Application for Works Approval

Works Approval Number W6714/2022/1

Applicant BHP Iron Ore Pty Ltd

Date of report 2 February 2023

Figure 1: TSF1 and TSF3 Layouts

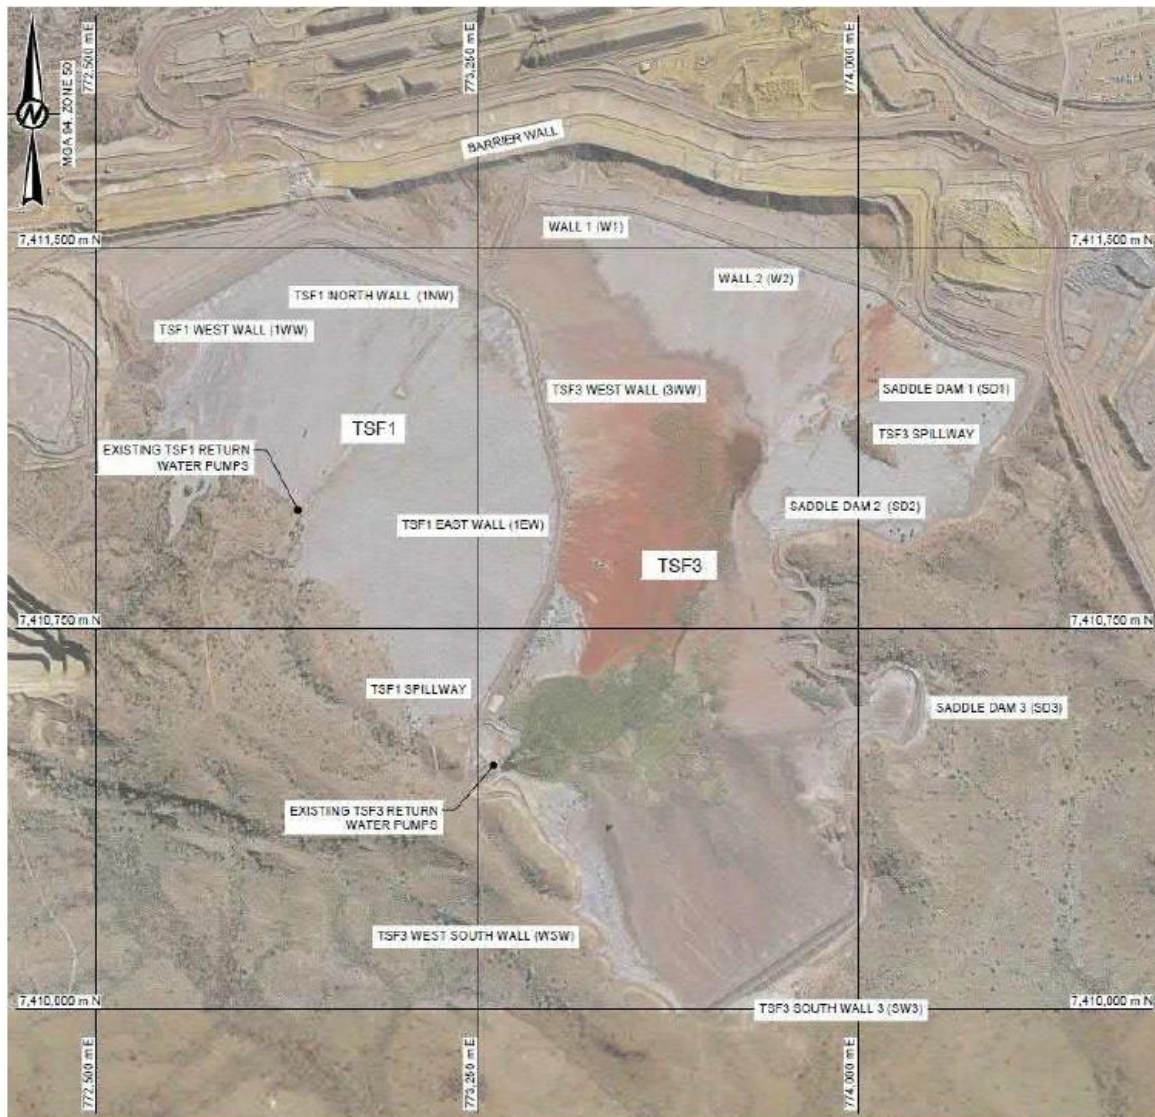
Condition	Summary of applicant's comment	Department's response
-	Updated premises map, Figure 1 with the inclusion of the on-site weather station.	-
1, Table 1	<p>BHP currently has a weather station installed at the location shown on the updated Figure 1 (attached). This station is currently not compliant with</p> <ul style="list-style-type: none"> AS/NZS 3580.1 (siting). AS 3580.14 (operation). <p>BHP is not proposing to upgrade the weather station to AS/NZS 3580.1 (siting) or AS 3580.14 (operation) as the current data provided from the station is considered sufficient to monitor both rainfall and evaporation at the site. Regional evaporation is well understood and there is also a weather station located at Newman Airport that can be used to compare to the onsite station. BHP considered that the current station therefore provides sufficient inputs into the TSF water balance model to enable the facility risks to be adequately managed.</p> <p>Based on this BHP would like to request that the reference to AS/NZS 3580.1 (siting) or AS 3580.14 (operation) for the weather station is removed from Table 1.</p>	<p>The Department has removed the installation of a weather station from Condition 1, Table 1.</p> <p>On-site weather station is listed under Condition 11, Table 3 to indicate the operational requirements (i.e., record monthly site rainfall and evaporation rate) and the infrastructure location as indicated in the updated premises map, Figure 1.</p>
